**Re: LPSC DOCKET NO. I-34715, IN RE: INTEGRATED RESOURCE PLANNING  
("IRP") PROCESS FOR SOUTHWESTERN ELECTRIC POWER COMPANY  
(SWEPCO), PURSUANT TO GENERAL ORDER DATED APRIL 20, 2012**

SIERRA CLUB'S COMMENTS  
ON SOUTHWESTERN ELECTRIC POWER COMPANY'S  
DRAFT INTEGRATED RESOURCE PLAN  
(PUBLIC VERSION)

**Figure 3: Expected Surplus Capacity in SWEPSCO’s Preferred Plan<sup>14</sup>**

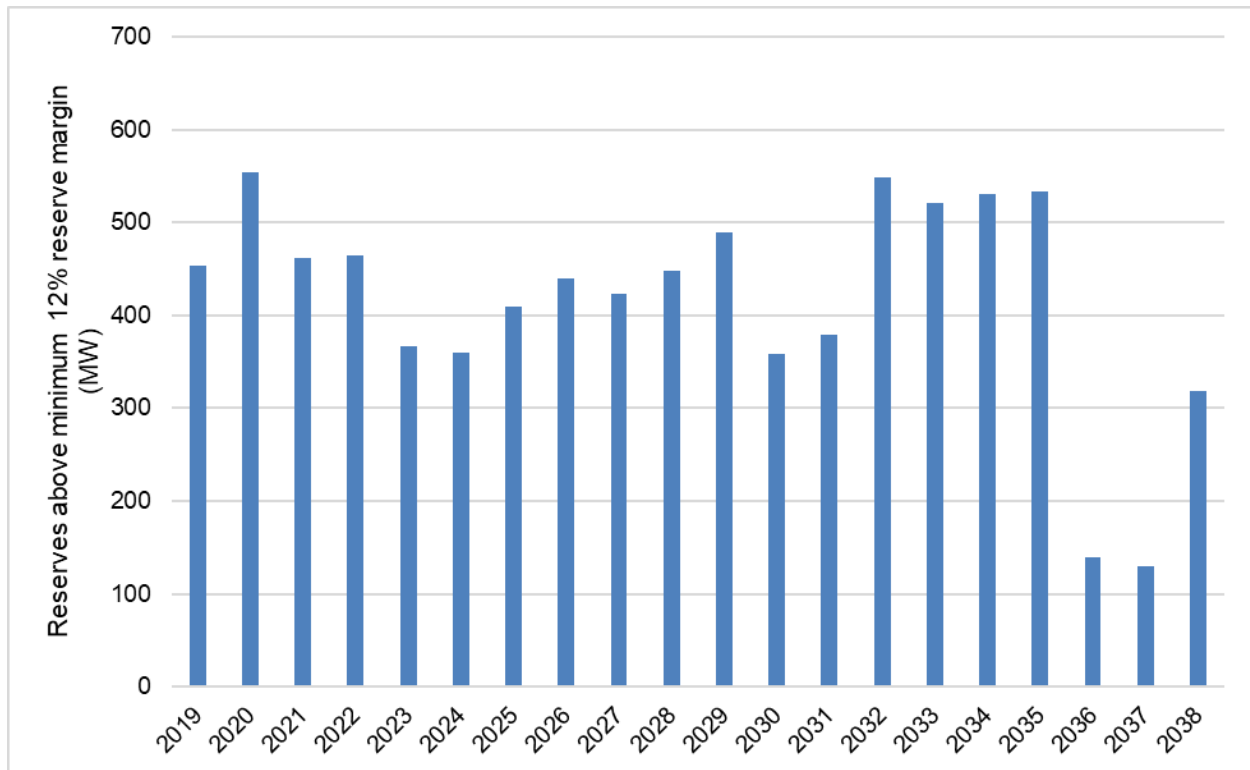
SWEPCO’s failure to conduct an optimized retirement analysis is particularly concerning because it exposes ratepayers to future risks and costs of coal generation—as we discuss further. Under its preferred plan, SWEPCO would have enough capacity to facilitate cost-effective unit retirements (see Figure ). Indeed, there is question of whether the Company could procure even more new capacity, than under its preferred plan, if the selected new resources were lower-cost. The Company fails to ask this question.

Figure 5: SWEPCO IRP and EIA AEO Henry Hub Natural Gas Prices (\$/MMBtu)<sup>18</sup>

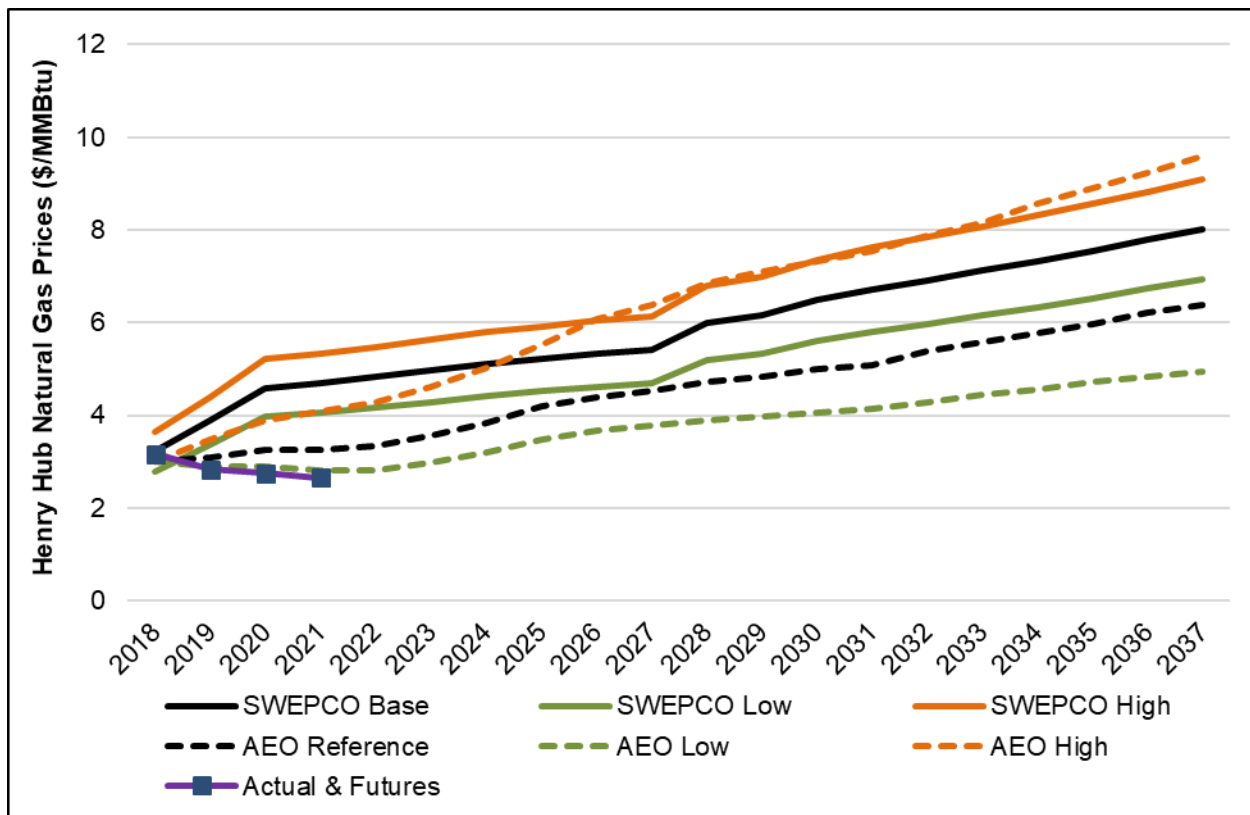
A higher gas price leads to a higher electricity price and, as a result, higher revenue for each unit of energy generation by SWEPCO’s units. Therefore, the future gas price is an important determinant of the forward-looking economics of the coal fleet. However, SWEPCO’s low, base and high natural gas price forecasts skew high compared to current projections from the U.S. Energy Information Administration’s 2019 Annual Energy Outlook (AEO)—as shown in Figure .<sup>17</sup> Even SWEPCO’s low gas price sensitivity is higher than the AEO 2019 base case. This indicates that SWEPCO’s low gas sensitivity is too high, even if they were the base case. Indeed, the AEO low gas price case is in-line with gas futures market prices which are also shown below. SWEPCO’s high gas sensitivity far surpasses the AEO high bound through 2025. In sum, the Company’s forecasts all skew high, which would lead modeling results to unfairly favor coal generation.

Figure 6: SWEPCO IRP and EIA Powder River Basin Coal Prices (\$/ton)<sup>20</sup>

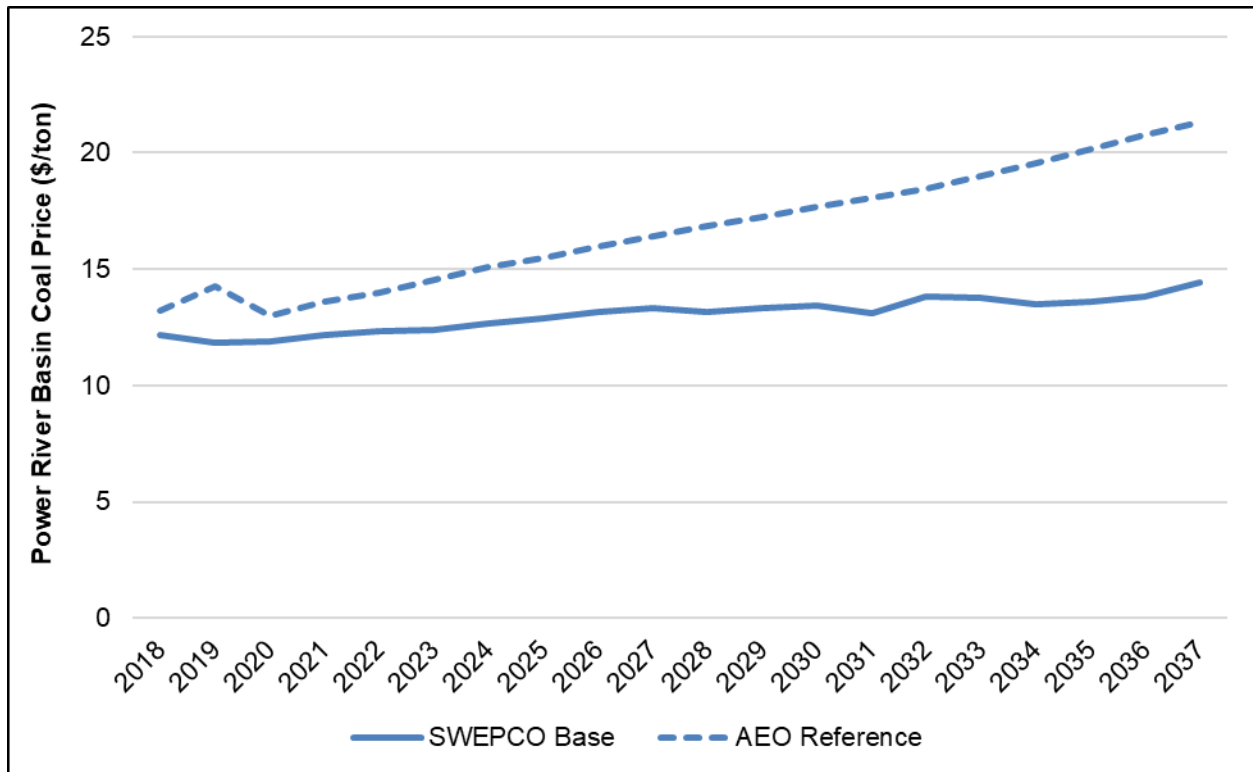
Second, SWEPCO’s reference Powder River Basin (PRB) prices are much lower than the corresponding prices reported by the AEO 2019—shown in Figure .<sup>19</sup> As with high gas prices, low coal prices make coal generation appear more competitive against other resources. While we have not been provided access to modeling results in SWEPCO’s IRP, review of the key assumptions shows that they are skewed in favor of coal generation.

**Figure 29: Difference between passive DSM in SWEPCO June 2018 load forecast and January 2019 IRP (assumed to be cumulative)<sup>65</sup>**

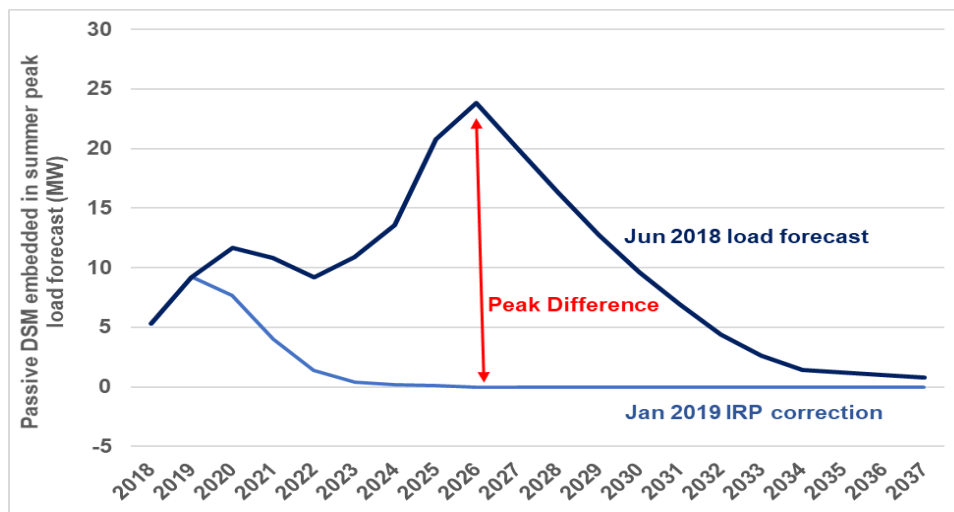
SWEPCO’s assumptions about how much passive DSM is included in its load forecast decreased between June 2018 (when SWEPCO conducted its load forecast) and January 2019 (when SWEPCO submitted its IRP).<sup>64</sup> In its IRP, SWEPCO assumes that state-approved DSM programs ramp down in 2021. The impact of this change between the load forecast and the IRP results in a maximum increase in summer peak demand of 24 MW in 2026 (Figure 29).

**Figure 30: SWEPCO IRP passive DSM forecast reduction<sup>67</sup>**

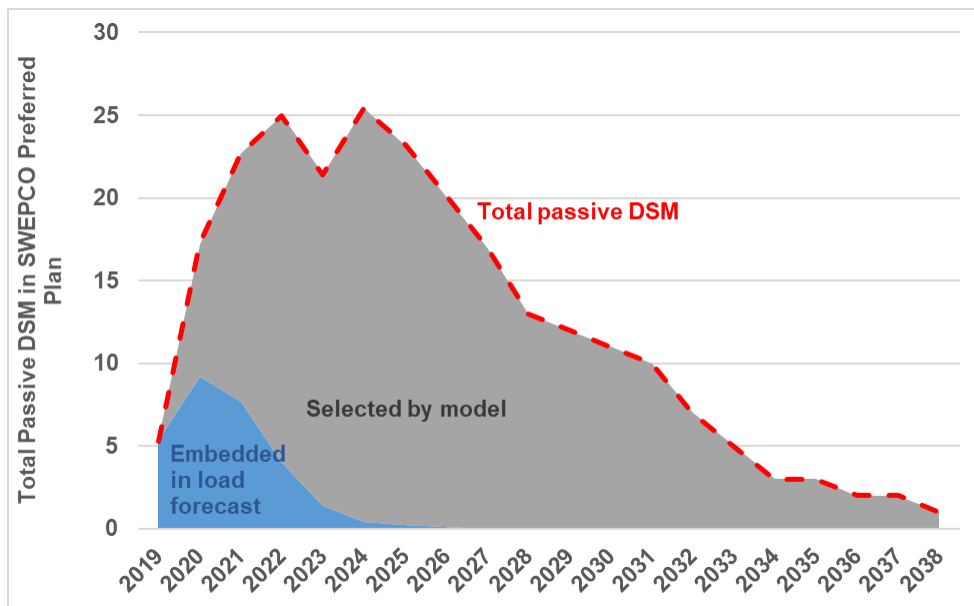
SWEPSCO’s IRP also models additional passive DSM as a resource for future capacity, in addition to the amount embedded in the load forecast. Beginning in 2020, a total of 721 GWh (equal to 2 percent of SWEPCO’s total load) was made available for resource selection in modeling.<sup>66</sup> The passive DSM included in SWEPCO’s preferred plan reaches a maximum of 25 MW in 2022 and again in 2024 (Figure 30).

SWEPCO’s presentation of its treatment of passive DSM in its IRP is not transparent for third-party review and no explanation is provided for why SWEPCO assumes that state-approved DSM ramps down in 2021.

Figure 5: SWEPCO Preferred Plan Surplus Capacity with 5 MW energy efficiency savings year-on-year<sup>69</sup>

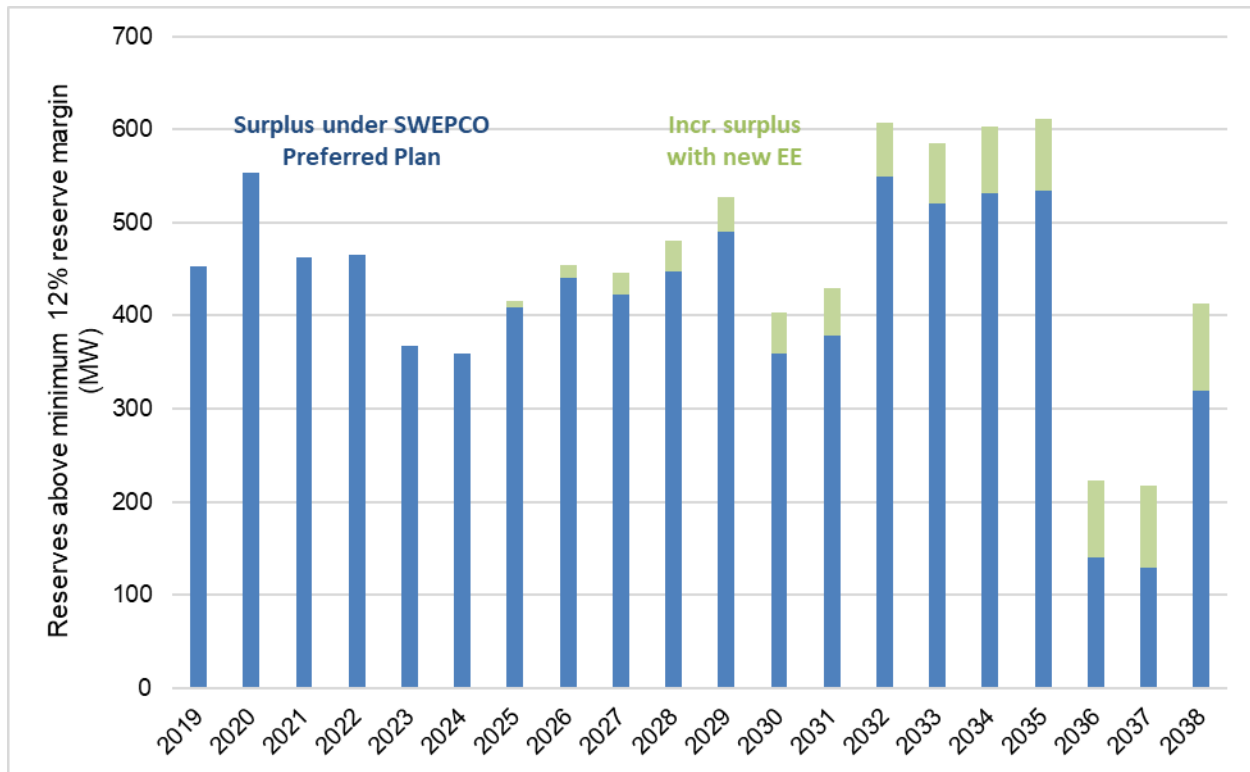
SWEPCO’s Preferred Plan includes 218 MW of energy efficiency through 2038. However, the amount of energy efficiency included in the Preferred Plan only increases year-on-year through 2024 (with one exception: it decreases between 2022 and 2023 by 1 MW), after which point annual energy efficiency savings decrease year-on-year through the remainder of the planning period. We modeled what SWEPCO’s capacity position would be if SWEPCO were to continue to increase energy efficiency savings year-on-year after 2024 by 5 MW: the average amount that SWEPCO’s energy efficiency savings increased between 2019 and 2024. The results are shown in

Figure 5, which demonstrate that—if SWEPCO were to commit to increasing energy efficiency every year in the planning period—their capacity surplus position would rise by 7 MW in 2025 up to 94 MW in 2038.
